UPPER UWCHLAN TOWNSHIP
PLANNING COMMISSION
AGENDA

**April 11, 2024
6:00 p.m. Workshop, 7:00 p.m. Meeting**

PRELIMINARY LAND DEVELOPMENT PLAN EAGLE ANIMAL HOSPITAL

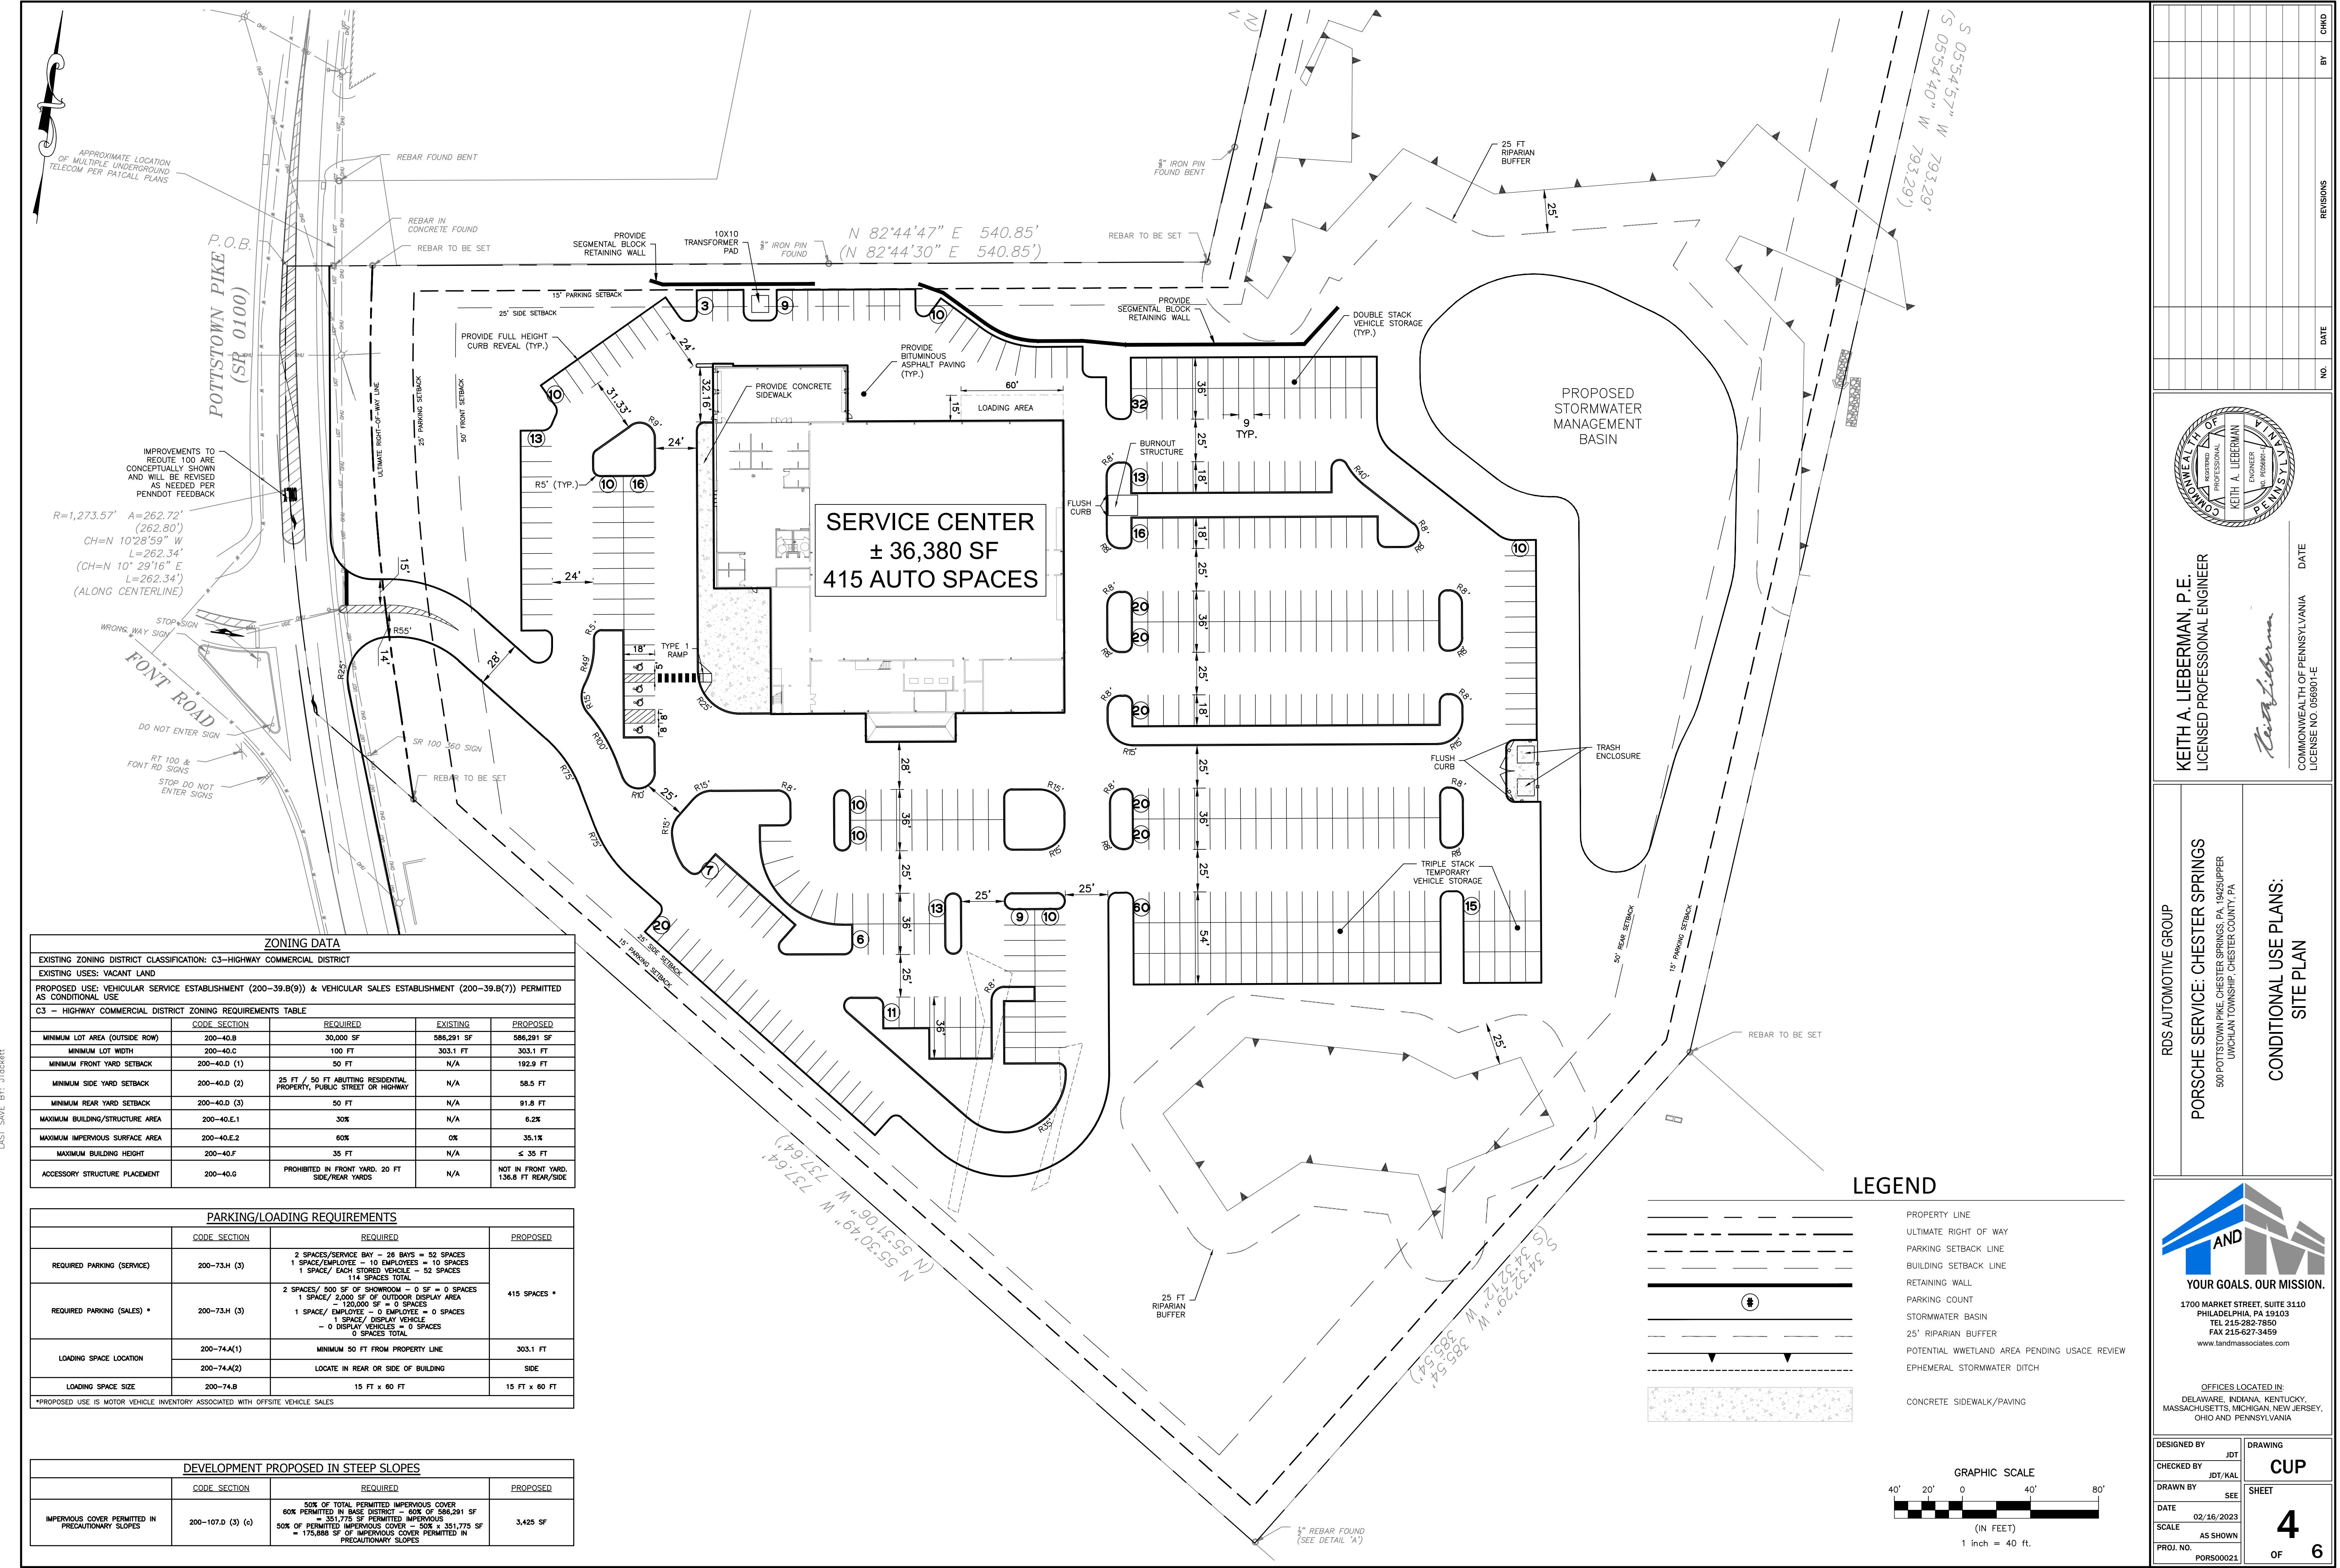
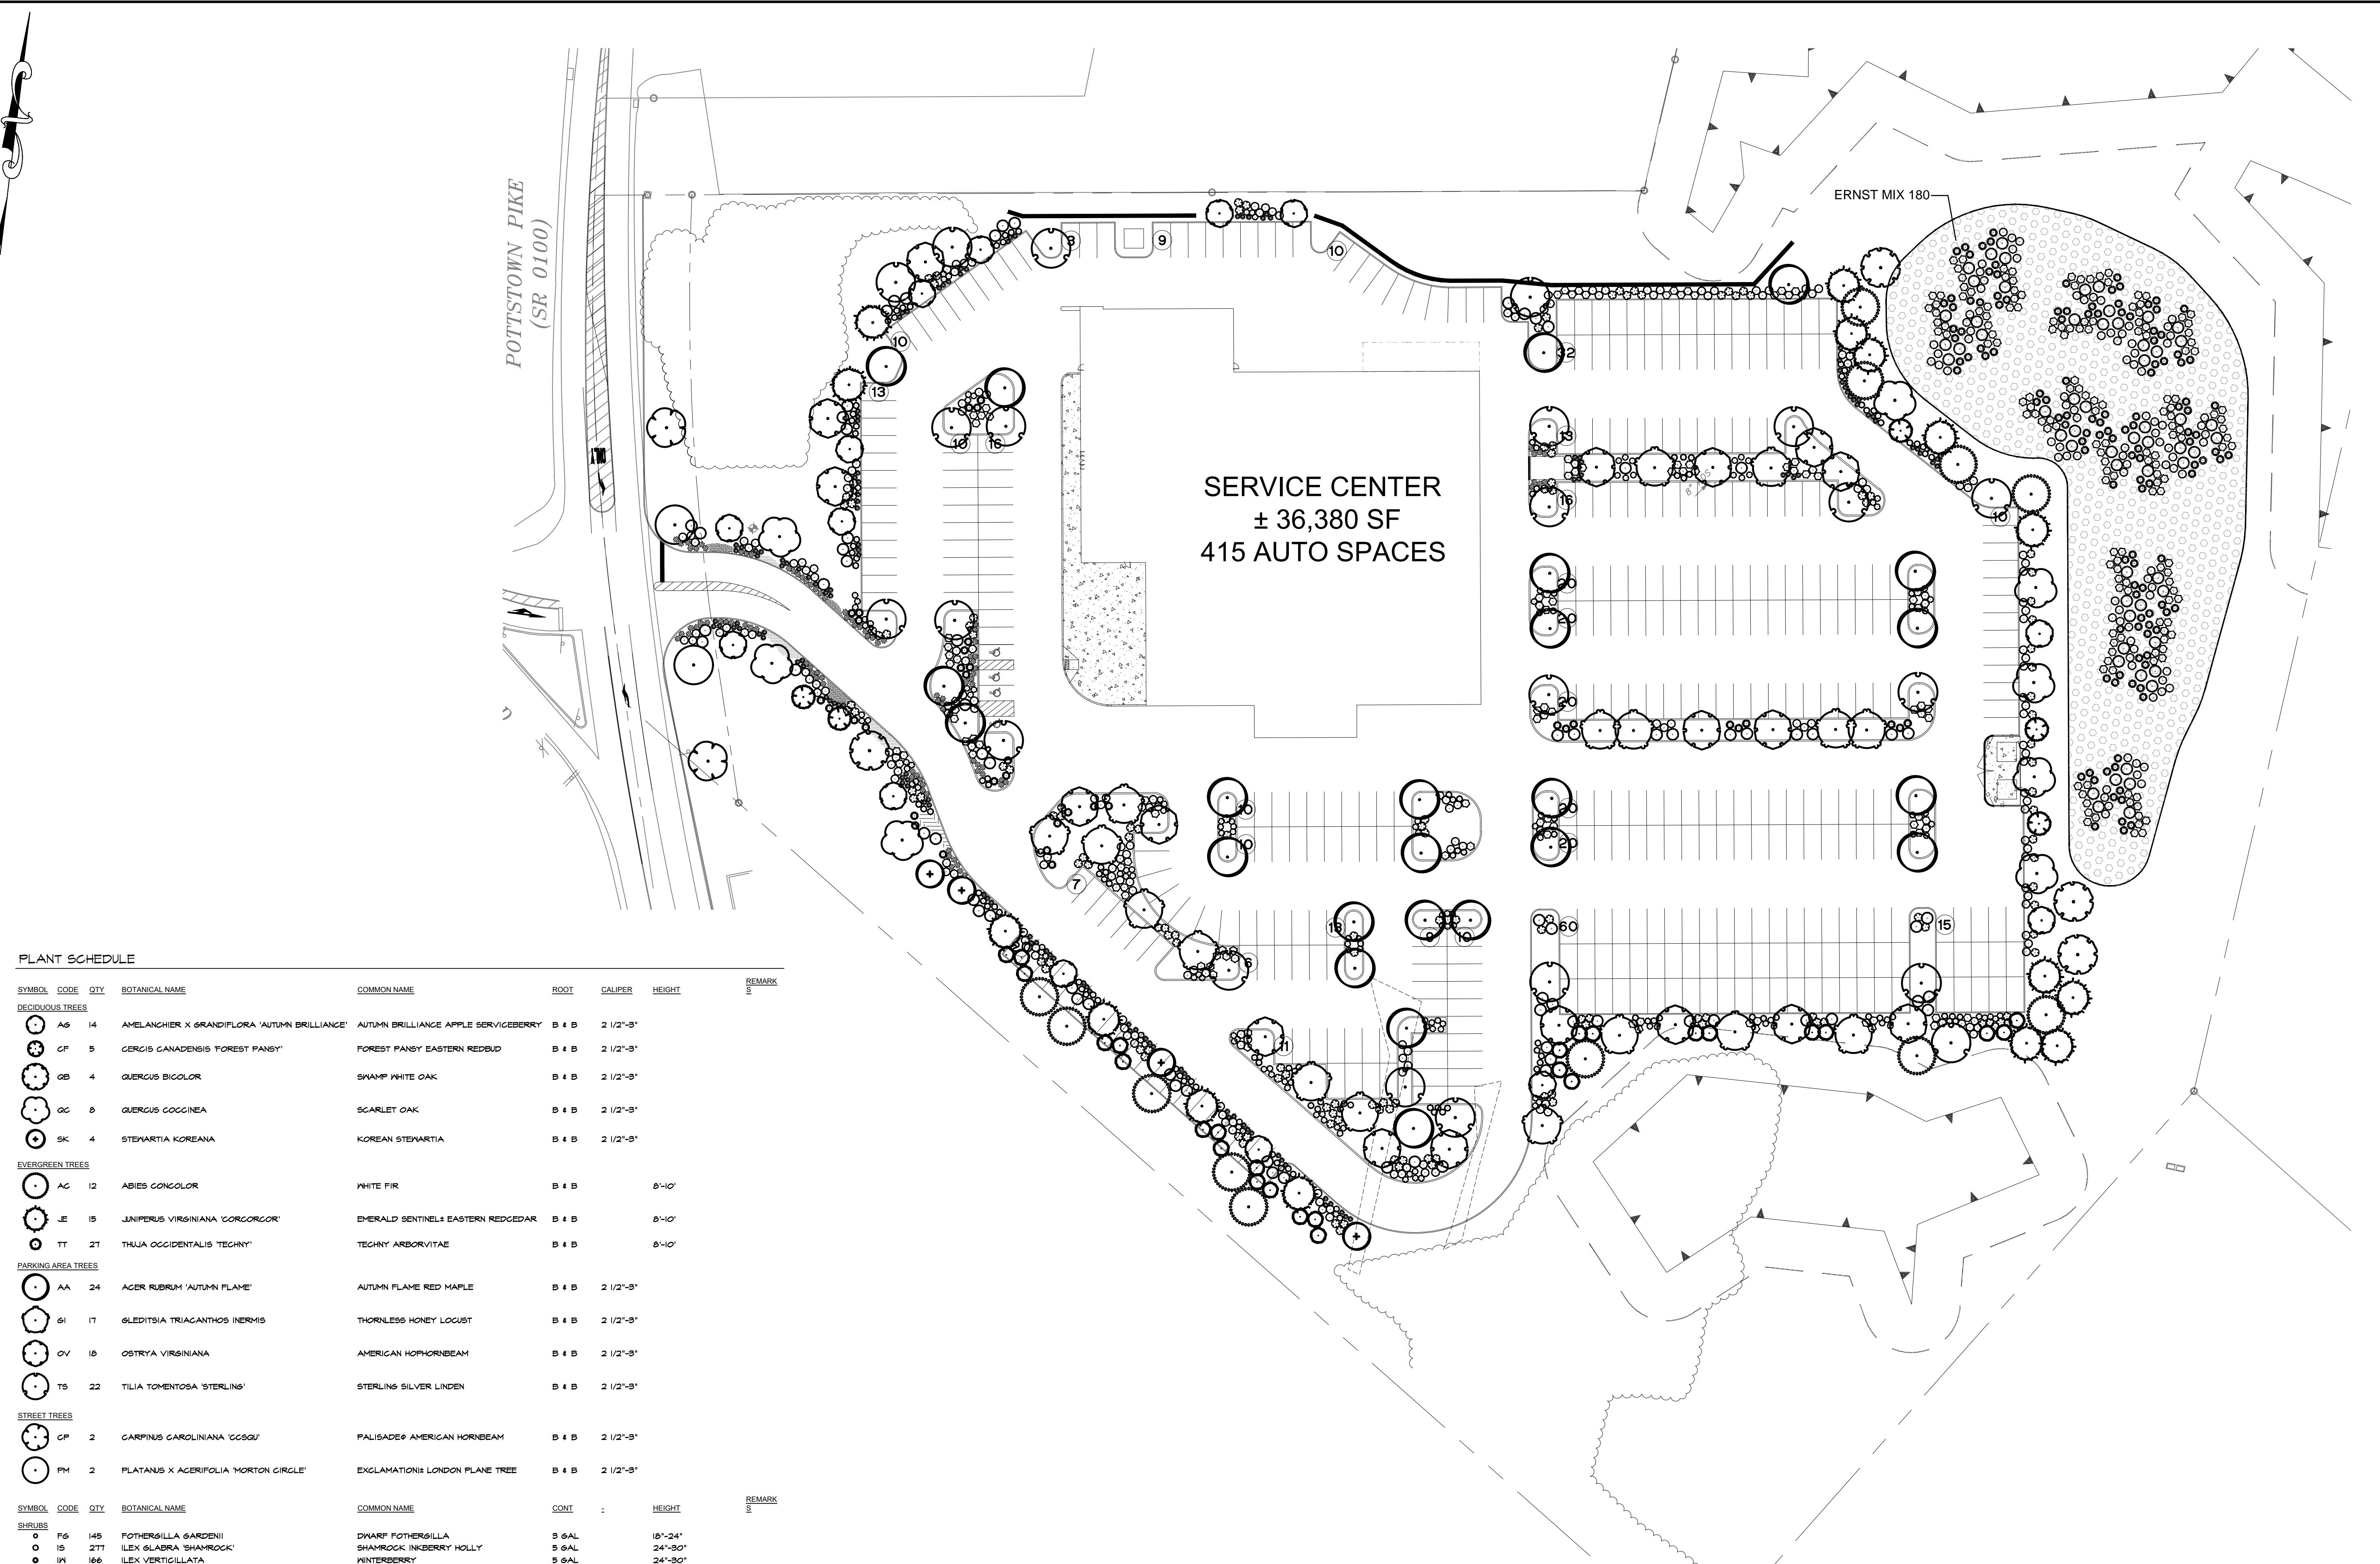
12. ZO Section 200-73.H and 200-73.K – According to the parking/loading requirements table on sheet 4, the site only requires 114 parking spaces, including 52 spaces for stored vehicles. However, the site provides 415 parking spaces, which exceeds the Township's parking supply requirements by 301 parking spaces. The applicant should provide additional justification for the proposed parking supply. The plans also indicate there are 91 double and triple stacked parking spaces, which indicates that it is proposed to store more than 52 vehicles on the site at one time. The proposed number of stored vehicles on the site should be accurately reflected in the parking calculation.

14. Sheet 5 includes a truck turning template for a fire truck circulating through the site. In addition, the plans should include a truck turning template for the largest delivery vehicle anticipated to visit the site, such as a car carrier tractor trailer.
